### INFORMATION REQUEST

**APPLICATION NO:** COM/84/2025  
**PROPERTY ADDRESS:** 20 CALUME COURT, LOGAN RESERVE QLD 4133, 1-15 CALUME COURT, LOGAN RESERVE QLD 4133, 43 NOFFKE COURT, LOGAN RESERVE QLD 4133  
**PROPERTY DESCRIPTION:** LOT 801 SP 337868, LOT 15 RP 182451, LOT 800 SP 337868  
**APPLICATION DESCRIPTION:**  
• **COMBINED APPLICATION – VARIATION REQUEST; RECONFIGURING A LOT (3 LOTS INTO 108 LOTS)**

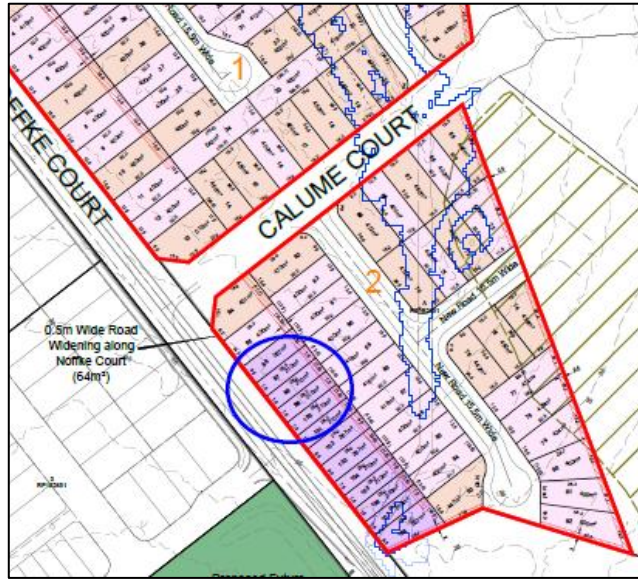
- 2.1. Remove proposed small lots (terrace lots) which are not adjoining/opposite public open space or proposed parkland.

*Lots 96-101 are not considered to be opposite public open space. Consider item 2.2 below on revised layout.*

LOW DENSITY RESIDENTIAL ZONE  
SUBURBAN PRECINCT  
EXAMPLE A

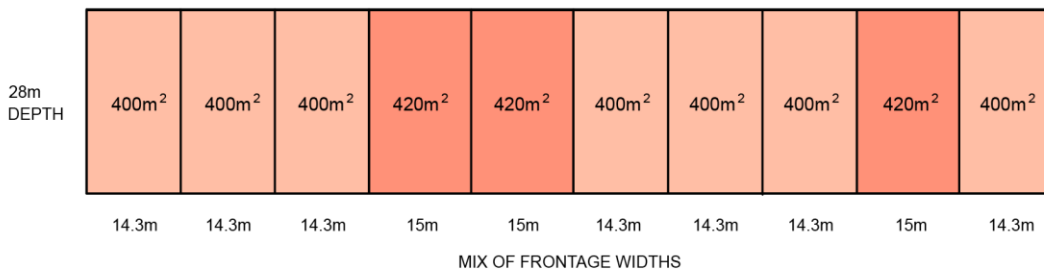
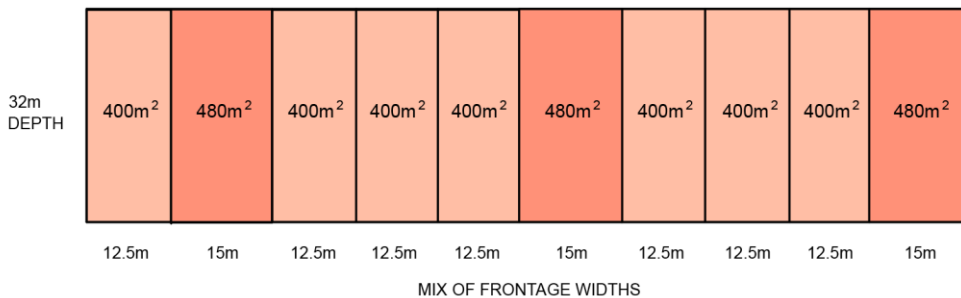
2.2. Provide an amended plan of development which incorporates improved variation in lot sizes and width throughout the proposed development, in accordance with Acceptable Outcomes (AO) 9.1 and 9.2, Performance Outcome (PO) 9 and Overall Outcomes 2.a.ii. and iv. of the Reconfiguring a lot code.

*Proposed lots 84 – 92 of the current subdivision proposal do not represent lot diversity, including the frontage width and lot size as required by Planning Scheme Policy 8 – Urban Design (PSP8). Please see Figure 2.3.3.1 – Example of diverse mix of frontage sizes in the Low density residential zone from PSP8 below. It is noted that lots should also provide for frontage width and lot size diversity as identified in Figure 2.3.3.3 – Example of diverse lot sizes facilitating a range of housing types from PSP8.*
